**Planning Commission
Staff Report**

February 27, 2008
Item 6.b.

SUBJECT: PUD-71

PURPOSE: Application for Planned Unit Development rezoning and development plan approval to rezone an existing 0.876-acre parcel from the RM-4,000 (Multiple-Family Residential) District to the PUD-HDR (Planned Unit Development – High Density Residential) District and to construct ten (10) townhouse units.

Originally Proposed Rear Elevation

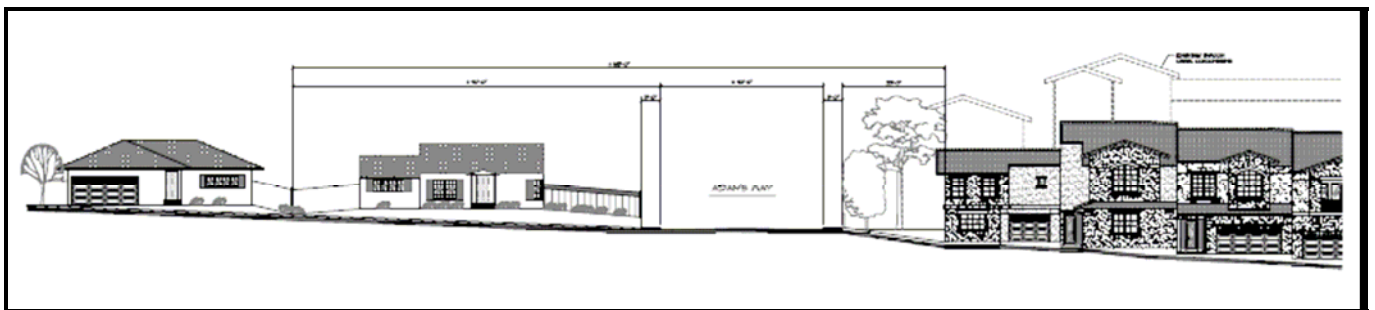
In response to the comments raised at the neighborhood meeting, the applicants have revised the designs to provide more interest and articulation on the rear elevations. The revised rear elevation exhibits gable roofs and wall articulations that mimic the front elevations. Below are the "before" and "after" elevations to demonstrate modifications.
